CENTURY CENTER PHASE 3

Applicant is requesting a replat of the property for a proposed Zaxby's development.

Approval of the request, subject to the conditions in this report.

PROPOSED SITE PLAN

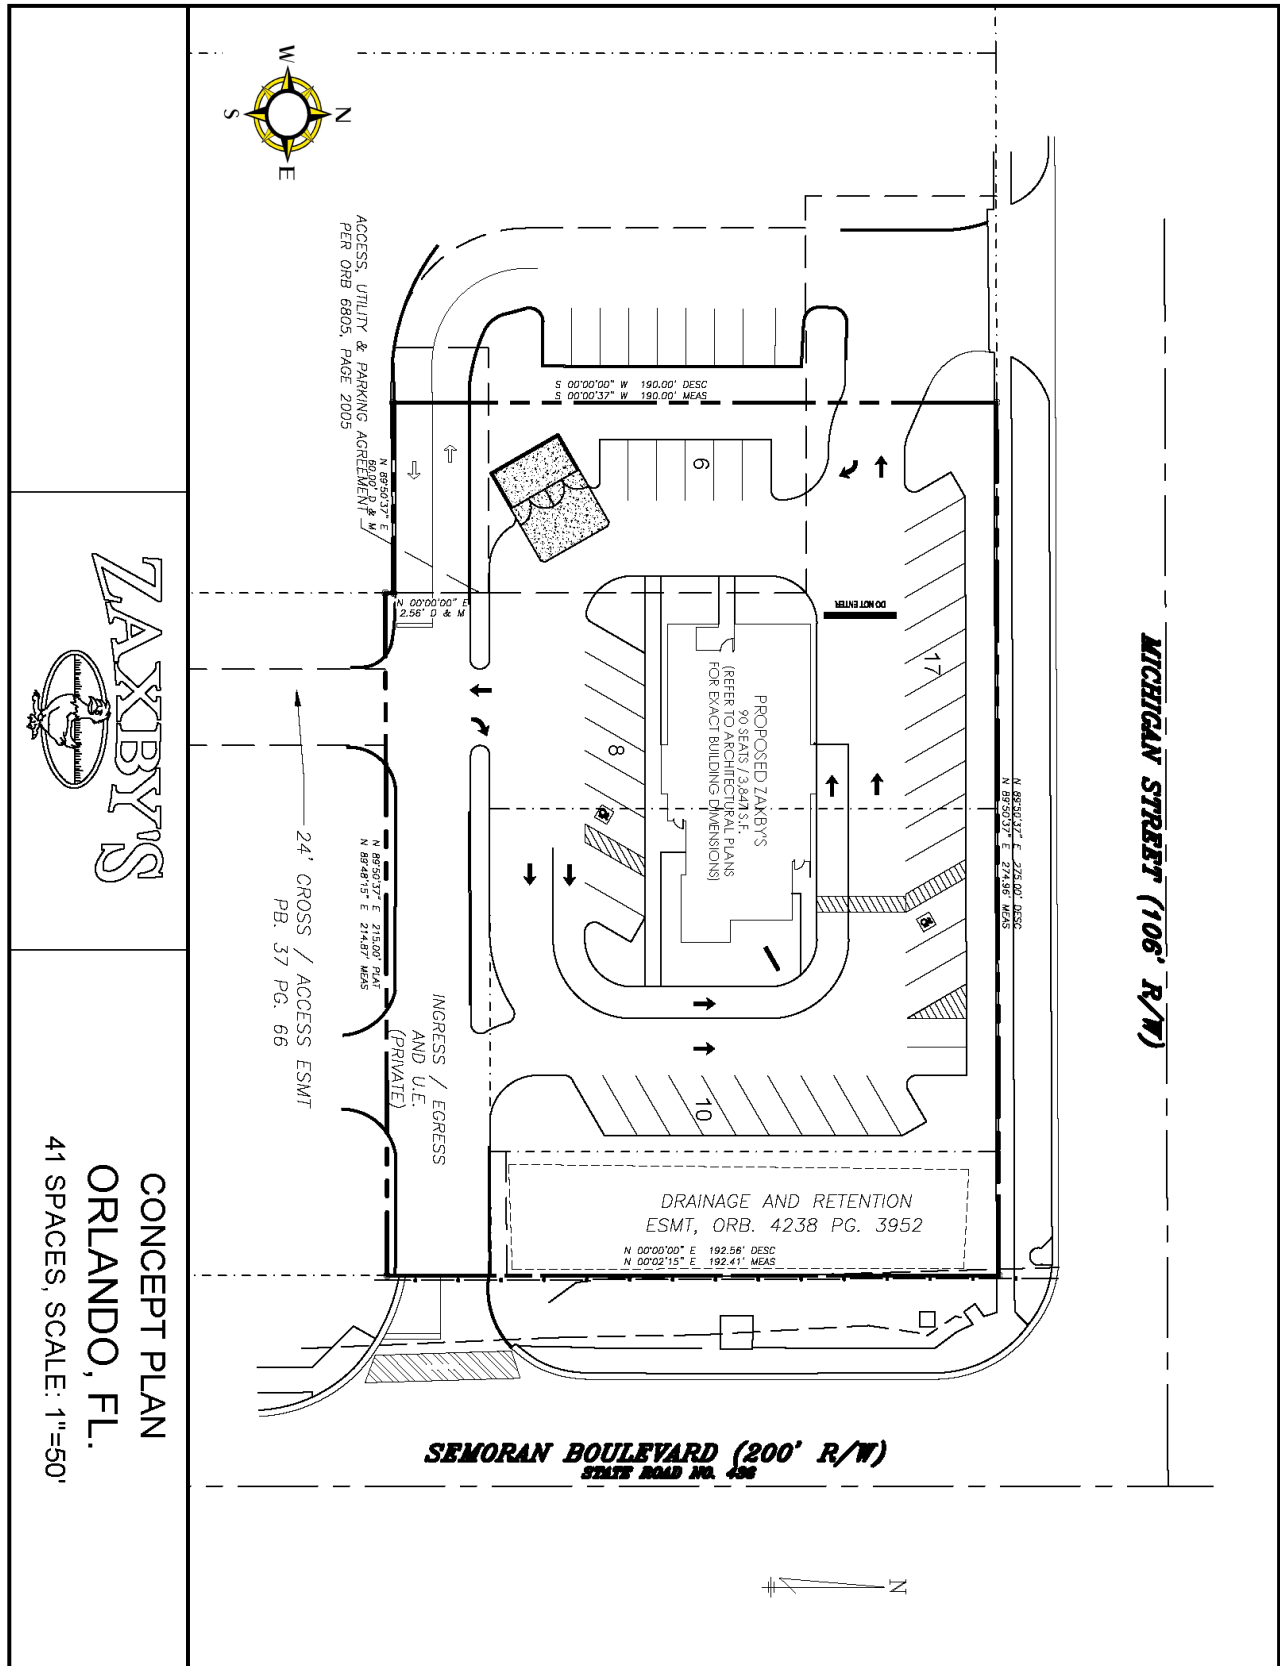
3. FAR. Floor Area Ratio shall comply with the AC-N/AN/SP zoning district requirement of 0.30.
4. Drive-through. Drive-through shall be redesigned to be oriented south of the property/proposed building, away from Michigan Street.
